Fieldgate - FXA320 - all variants

New software version : 01.02.03-072

Date: 24.10.2005
Author: Christian Seiler
Department: SupplyCare
Direct Tel. N°: +41 61 715 7281
e-mail: Christian.Seiler@solutions.endress.com

Fieldgate FXA 520 + FXA320 New Software Version 01.02.03-072

Linearization/SensorError/SensorTag Setup

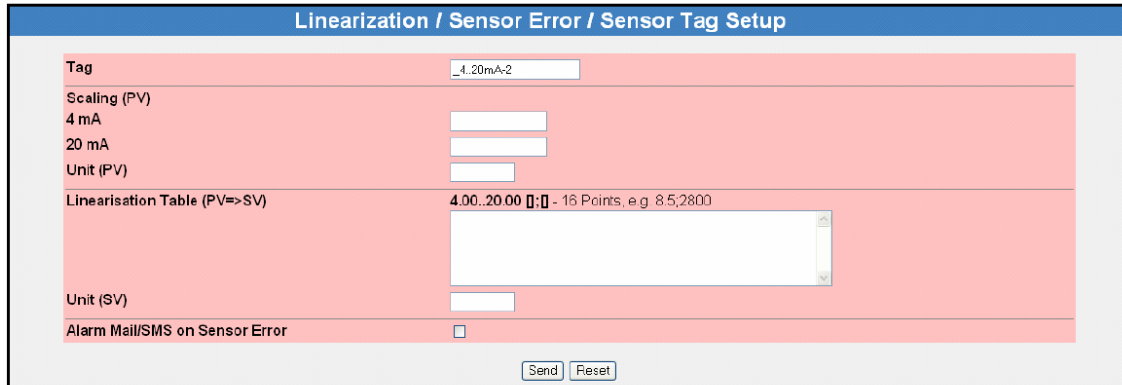
1.1 Linearization of 4-20mA inputs

For the internal 4-20mA analogue inputs, Fieldgate allows linearization with a linearization table. A maximum of 32 (16 FXA520) value pairs can be specified. The linearization table entries can be computed beforehand using a device tool such as the ToF Tool, for example, and copied into the appropriate field of the Fieldgate configuration using the "copy & paste" function.

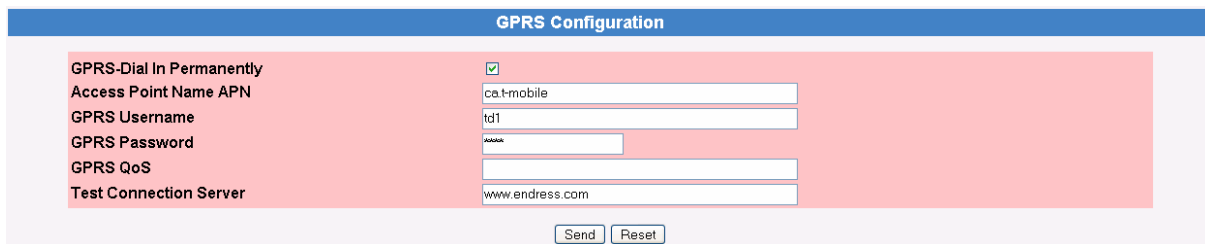
1.6 Unification of FXA320 and FXA520 user interface

Menu bar change: The HART Setup of the FXA520 is now located under "Scan Control".
